TRANSMISSION POWER CONTROL METHOD AND SYSTEM FOR CDMA
COMMUNICATION SYSTEM

Application No. 10/073,183

Replacement Sheet

Fig. 2
(PRIOR ART)

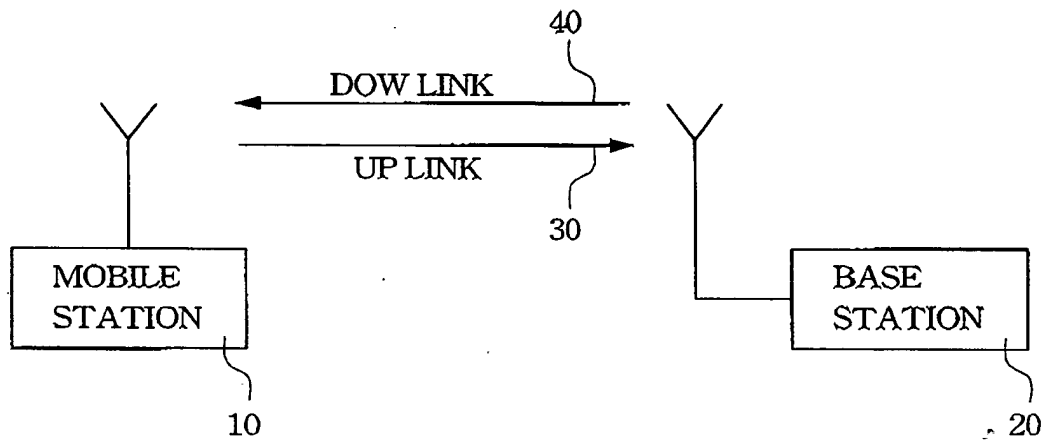
Please amend Fig. 2 as indicated by the Annotated Marked-up Drawing and the Replacement Sheet. The reason for the amendment is to correct an unintentional error in Fig. 2.
